Plan Change 29 – Addendum to the Section 42A Report

Open Space zoning at Station Bay – Lakeside Drive, Takapō / Lake Tekapo

| Subject: | Response to Landscape Evidence Submissions PC29.10 and PC29.29 - PC29 Rezoning Requests | | |

Figure 5 from Ms Crawford's evidence, view from 500m – The white line is my addition, an estimate of how far the east the Area b land parcel extends

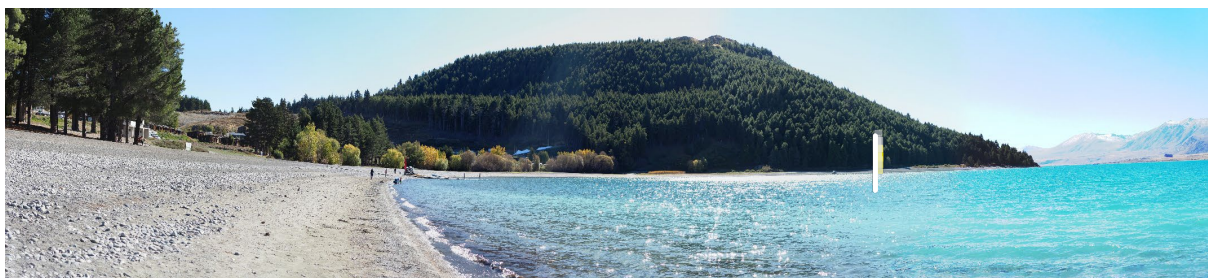
| <p>(c) When the area is viewed from approximately 500 metres away at the 'beach' (refer to Figure 5), again the scale and treed character of the hillside dominates. The lake level also plays a part in the visibility of the foreshore.</p> | Ditto my comments above about the trees. Development of Area B would be easily visible from here and based on my estimate would extend eastward to about the white line. From this distance any development would appear as an extension well beyond the Tekapo Springs extent. |

16. From this location any development would be easily visible and potentially prominent, appearing to extend well along the headland into the undeveloped landscape. From locations left of this viewpoint development would appear even closer to the end of the headland.
17. I consider the expansion of SARZ zoning and the resulting development within Area B would extend buildings and other infrastructure too far beyond the developed inner bay area along the undeveloped lakeshore. I also do not agree that the mitigating factors of the existing environment put forward by Ms Crawford (in the tables above) would effectively reduce the adverse visual and landscape character effects of permitted SARZ activity.
